Created by: Lab.gruppen AB Service Department

Reference no: Pot FP+

Symptom

Picture 1: Old type of potentiometers.

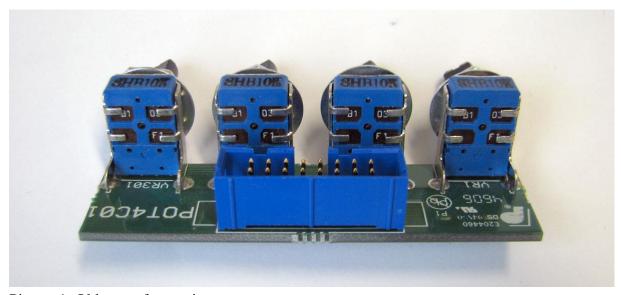
Distortion or dead channel due to bad potentiometers. Potentiometer VR10KLIN31HSBF replaces potentiometer VR10KLIN21H since the 21-step potentiometer has bad quality.

Old potentiometers (see picture 1 below) have plastic axis (black) and the new potentiometer have a steel axis. Both POT-board and UI-board needs to be exchanged since the new POT-board does not fit with the old UI-board.

UI12Lx203 and POT2B needs to be changed to UI12Lx205 and POT2B04 to get the new potentiometers to fit.

UI12Lx403 and POT4C needs to be changed to UI12Lx405 and POT4C03 to get the new potentiometers to fit.

Picture 2: The VR10KLIN31_TOK potentiometer.

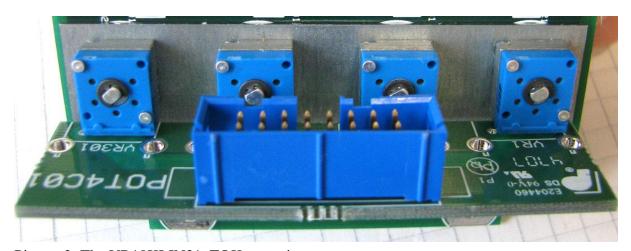
If the potentiometer VR10KLIN31_TOK (see picture 2 below) is mounted those does not need to be replaced, only potentiometers with plastic axis needs to be replaced. Difference between VR10KLIN31_TOK and VR10KLIN31HSBF is the supports on the sides.
